**RML UT2300249 – CONDITION 35
COMPLIANCE REPORT
- Revision 2**

**UTAH RADIOACTIVE MATERIAL
LICENSE - CONDITION 35 (RML UT2300249)
COMPLIANCE REPORT
(Revision 2)**

**For
Utah Department of Environmental Quality
195 North 1950 West
Salt Lake City, UT 84114-4850**

**EnergySolutions, LLC
423 West 300 South, Suite 200
Salt Lake City, UT 84101**

Figure 1-2, Federal Cell Below-Grade Depleted Uranium Capacity

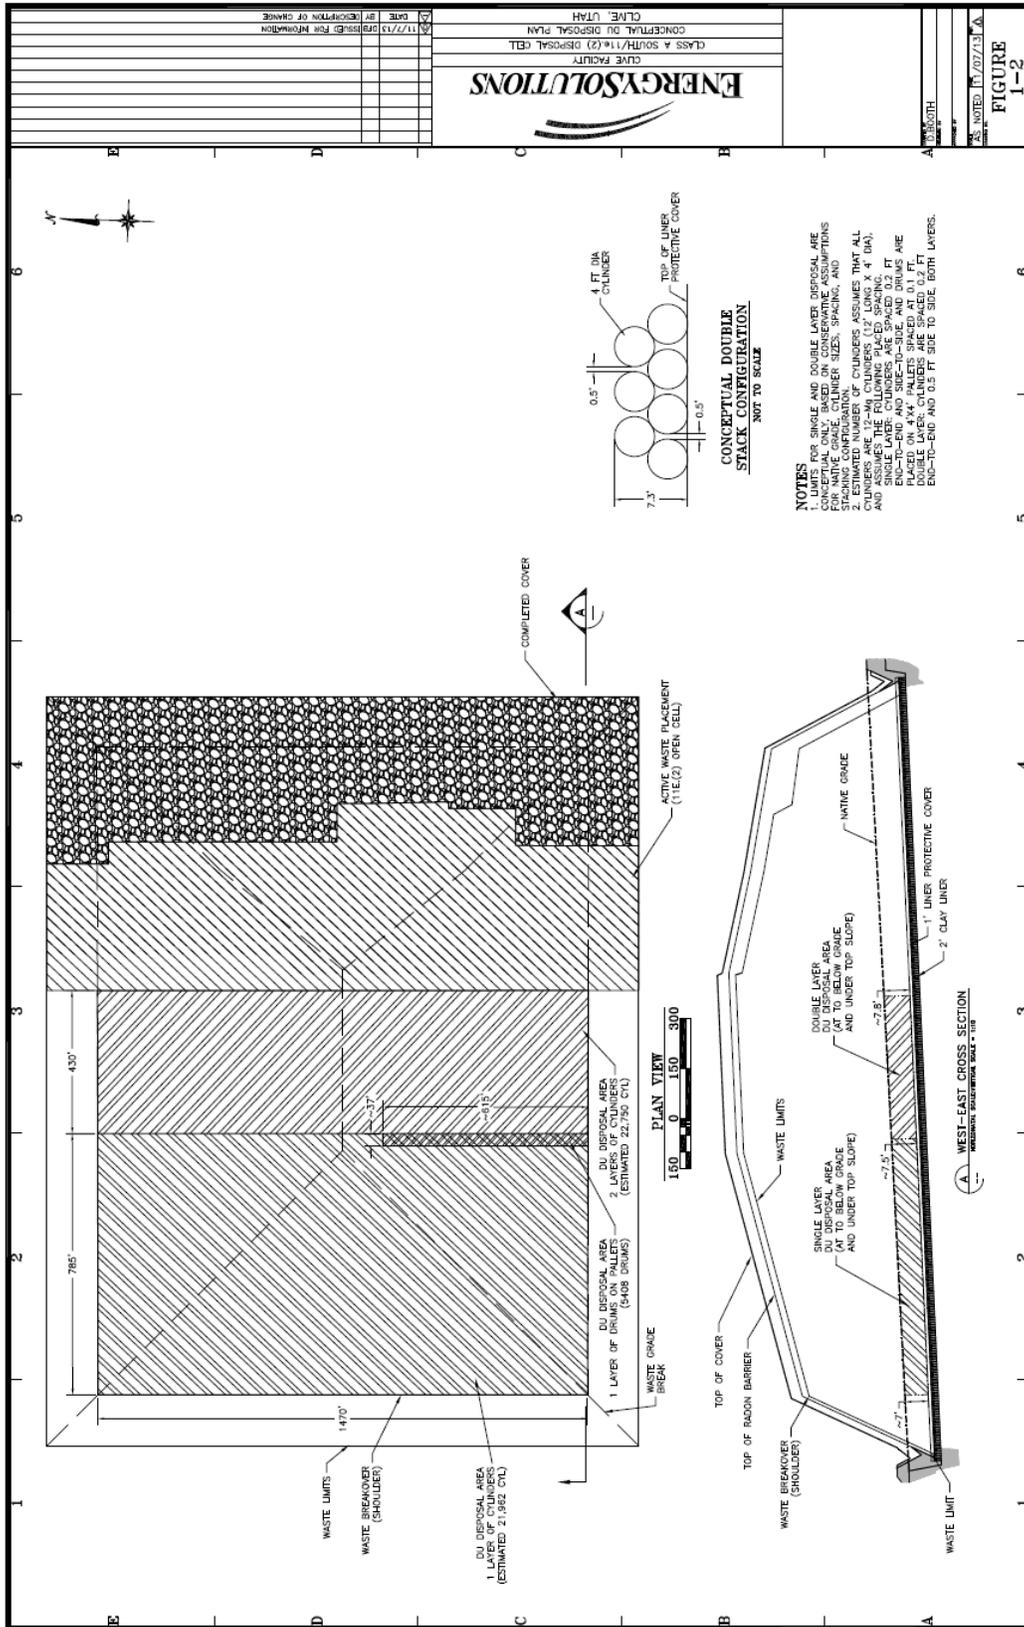
Explain how Figure 1-2 demonstrates that the entire inventory of DU can be disposed below grade. Provide calculations demonstrating that below-grade disposal will be achieved in the Federal Cell and that the burial depth is sufficient to protect the DU waste.

Resolve the conflicting statements about available thickness in the embankment for waste emplacement and emplacement depths. Explain and justify the plans given in the text of the PA given the information in Figure 1.2 and revise as necessary.

EnergySolutions' Response: Figure 1.2 has been clarified to reflect EnergySolutions' commitment that only a volume of depleted uranium that can be disposed of below grade in the Federal Cell will be managed, regardless of placement geometry.

EnergySolutions' Response: Figure 1.2 has been clarified to reflect EnergySolutions' commitment that only a volume of depleted uranium that can be disposed of below grade in the Federal Cell will be managed. Because

CONCEPTUAL DOUBLE STACK CONFIGURATION
NOT TO SCALE

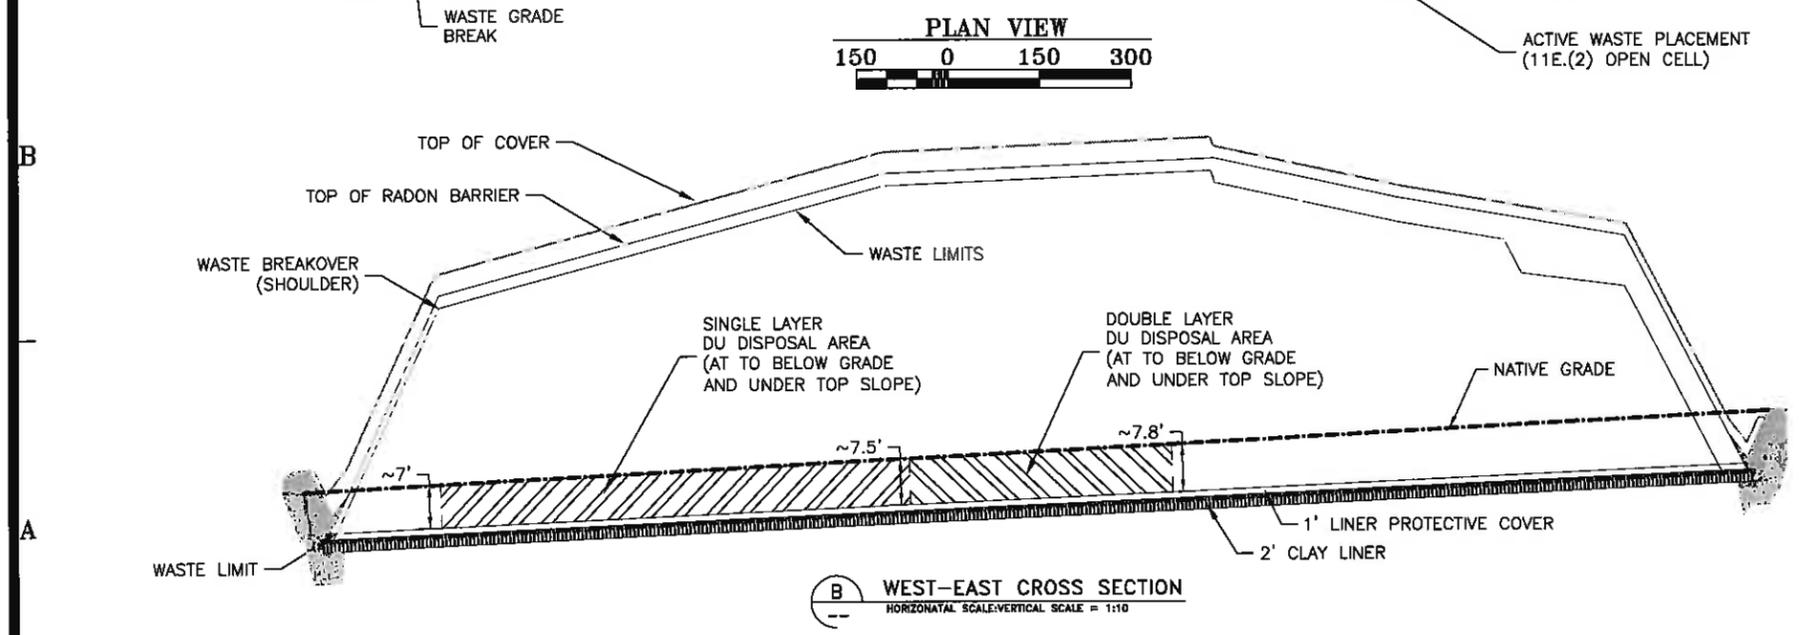
2:1 try spread value...
one on one....
